CITY OF HIGHLAND
REGULAR MEETING OF THE PLANNING COMMISSION AGENDA

PLANNING COMMISSION
REGULAR MEETING AGENDA
November 2, 2021 - 6:00 P.M.

2. Design Review Application (DRA 21-002) proposing the construction of a drive-thru carwash at an existing ARCO Gas Station located at the southwest corner of the Base Line and Seine Avenue intersection. (Continued from September 21, 2021) (27727 Base Line, APN No. 1201-091-45)

Revised Elevations

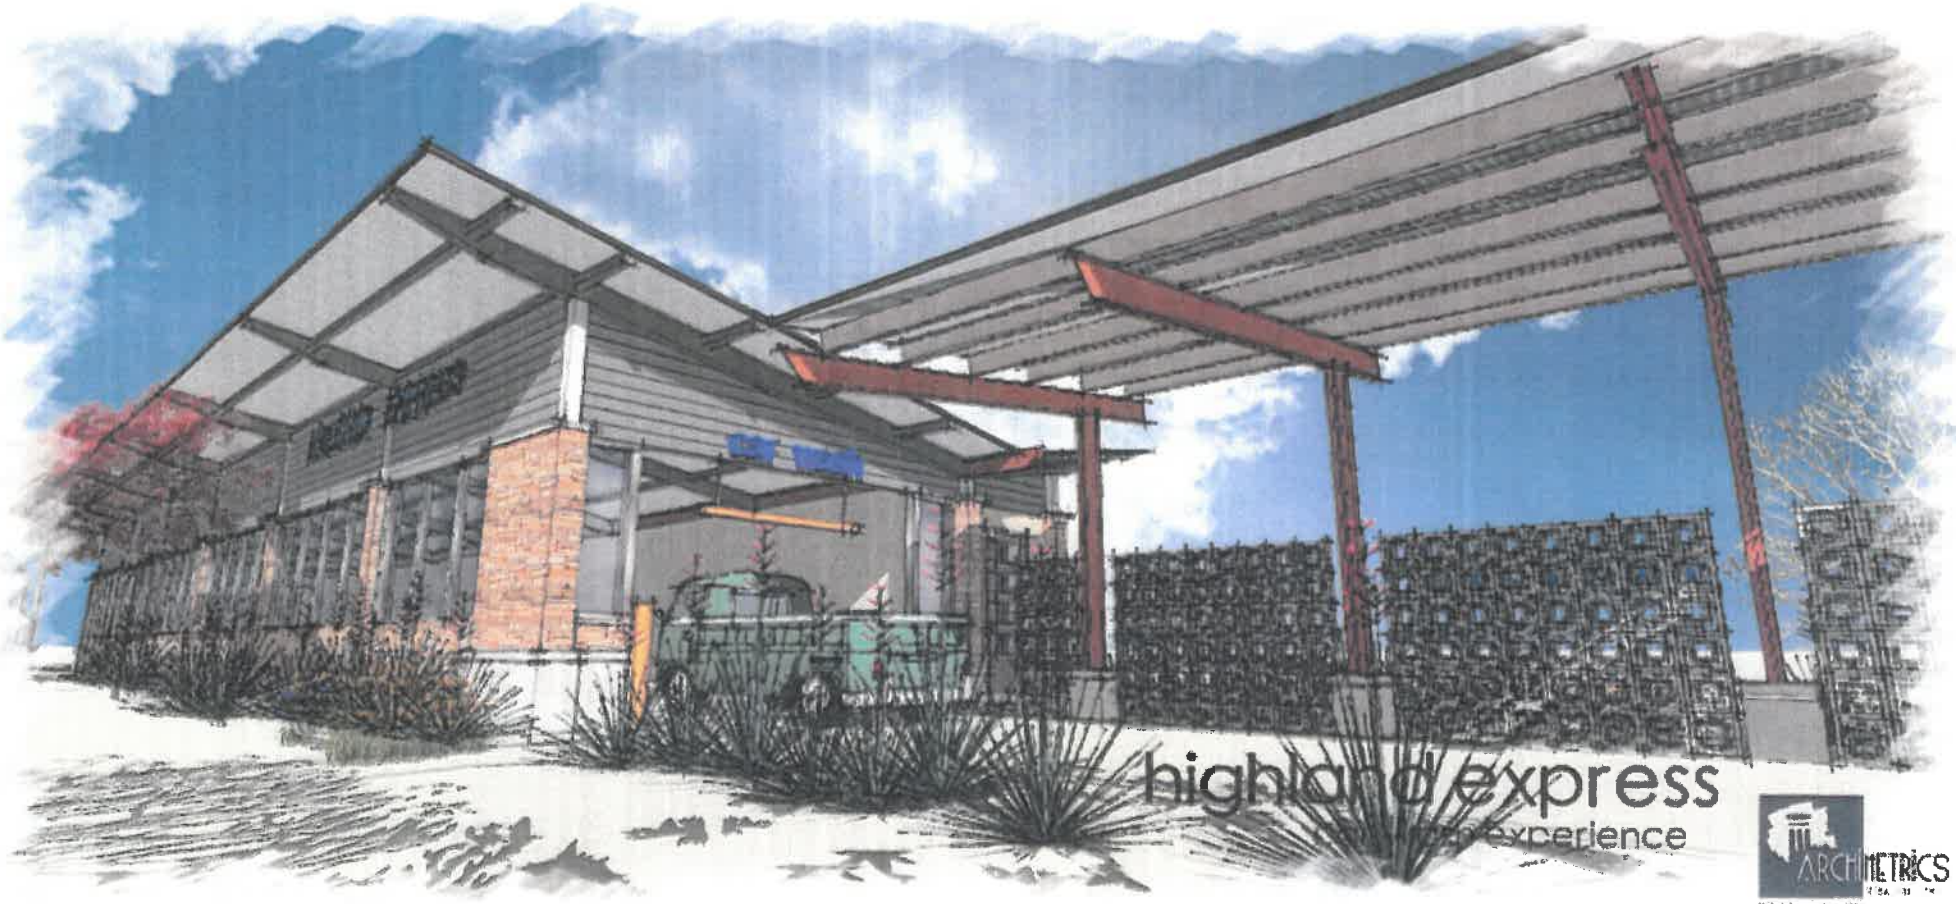
PREVIOUS ACTION: At the previous Planning Commission meeting held on September 21, 2021, the Commissioners reviewed the presentation and Staff Report and brought to the Applicant's attention some points of concern about the project and provided potential solutions. Staff mentioned that the proposed carwash building exterior appeared rather generic visually and did not incorporate any design features found on the existing convenience store and fuel canopy on the site. The Commissioners advised the Applicant to consider one of two potential approaches for the revision; 1) either keep the traditional taupe stucco exterior and add more visual accents, such as stone veneer siding and red clay tile roofing that matches the embellishments found on the other structures on the site; or, 2) or dissociate the carwash building entirely from the existing structures by distinguishing it with a modern design.

Chair Hamerly stated first we will go over the proposed architectural site plan. I know the floor plan doesn't include an equipment layout and this kind of impacts the elevations. The windows seem a little bit small, especially on the site side, and I've seen some car

Jay Nelson stated my objection to glass is, yes, it is a nice element to show off the internals, but because of the water spotting that normally occurs, especially once it hits the slab and bounces up it will spot. I would recommend against lowering the glass.

Chair Hamerly stated that works. It's just a very long low building and anything we can do to break up the long horizontal lines is going to add a lot, and I know that landscaping is going to help us out, but not a lot. The mesquite is not a screening thing, it's an accent. If we're changing the plant palette to add something that truly is designed as a screen there might be some options where we put an wire grid on that and run a creeping material up through one of those recesses. That's an option if you want to do it out of landscaping, otherwise, breaking up the pattern and putting another color in there might be an option as well. I'll leave it to your discretion and the owners budget tolerance.

Community Development Director Mainez stated the blue element on this elevation is purely an ARCO image not to say this is going to happen, but gas stations do change ownership. My point was it should match the building and your point maybe it's too low, maybe it needs to be raised up. It's right off the freeway there'll be a sound wall so we may not see it from the freeway, but the residents are going to have to use this every day and we're trying to create a sense of place.

ANALYSIS: The Applicant has since provided Staff with updated elevations, opting to take the ultra-modern design approach, one of the suggestions by the Planning Commission. The revised design includes a canopy over the drive aisle that features exposed steel beams and a tilted solar panel platform which also functions as a roof. The carwash building exterior features an angled metal roof with gray vinyl slats around the upper section of the perimeter. The remainder of the siding consists of the stone veneer cladding with large windows for added visibility into the carwash building. Not previously included as part of the initial design are vacuum stations on the site. With this revised design, the Applicant has opted to include four (4) stalls directly east of the carwash building dedicated to vehicle vacuuming.

At the September 21, 2021 Planning Commission meeting, there was discussion concerning whether it was practical to include some of the exterior façade treatments from the convenience store building on to the proposed carwash. Since the meeting, the Applicant did not submit renderings to Staff that demonstrated whether this request could be an acceptable option for the Planning Commission's consideration. That being the case, Staff is requesting the direction from the Planning Commission to determine whether the proposed architectural revision to the carwash, as submitted for consideration, is appropriate as an addition to an existing gas station use. If Planning Commission feels the proposed design is appropriate, Staff will revise the Design Review Application Findings of Fact to support the Planning Commission determination and bring the revised findings at back the next meeting. Should the Planning Commission wish to direct the Applicant to apply some of the exterior façade treatments from the existing convenience store building, it would be appropriate to continue the item to allow the Applicant additional time to prepare renderings. No revisions to the findings will be required for this.

Revised Landscape Plan

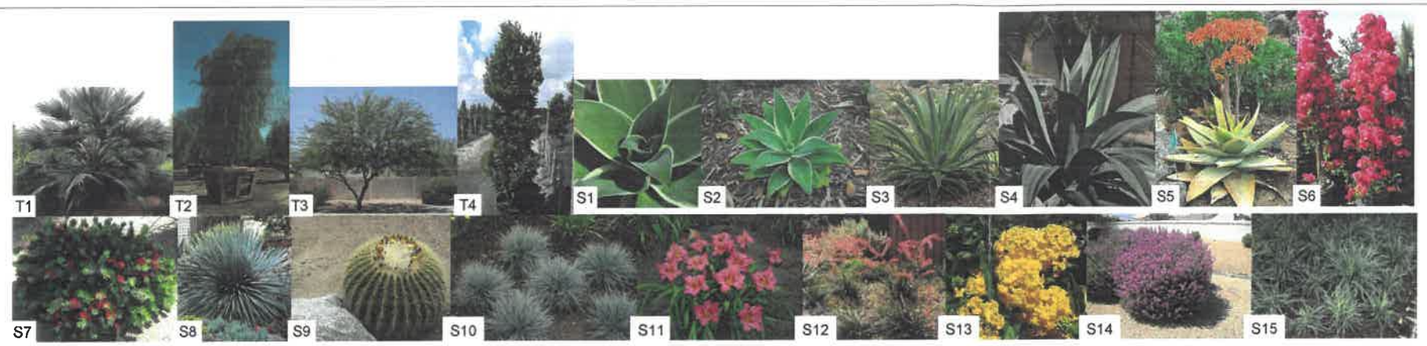
Additionally, the Commissioners expressed concern over the existing landscaping on the site that has been neglected over the years. As aforementioned in the report, the revised landscaping on this site will address and correct the outstanding Code Violation on this site. Further, there was concern and confusion on behalf of the Applicant regarding the exact location of the ultimate right of way along the 210 freeway offramp and along Base Line. The Planning Commission took Staff's direction and has requested the Applicant provide a more accurate plan with additional landscaping around the site, up to the block wall along the 210 freeway offramp and to the back of sidewalk along Base Line. Lastly, the Commissioners expressed concern over the sparse landscaping at the southwest corner of the site. The idea was that when drivers exit the carwash building during the evening hours, their vehicle's headlights will be aimed directly at and into the homes located on the south side of Pluto Street. To mitigate this issue, the Commissioners

suggested additional and denser plants around the landscape buffer where the drive aisle curves back toward the site. The item was continued to the November 2, 2021 Planning Commission meeting.

Commissioner Miller regarding the landscaping plan, I think the Mediterranean Fan Palm is an invasive species, isn't it?

Commissioner Miller stated It looks like there's two proposed parkway drains coming out. Those are coming out at 90 degrees to Pluto Street. Water doesn't like to bend around 90 degrees and my concern would be there to avoid a real substantial offsite analysis on Pluto Street would be to take the parkway drain and see if we can move that closer to that existing outlet. The concern there is if the capacity of the north side of Pluto Street gets exceeded then you're going to spill down Dunkirk, and you're going to change that historical drainage pattern. Something to consider about trying to preserve that that existing drainage condition.

Lastly, the Landscape Plan incorporates additional plants at the southwest corner of the property, adjacent to the carwash exit lane, and includes landscaping to improve the neglected areas and address the outstanding Code Violation.
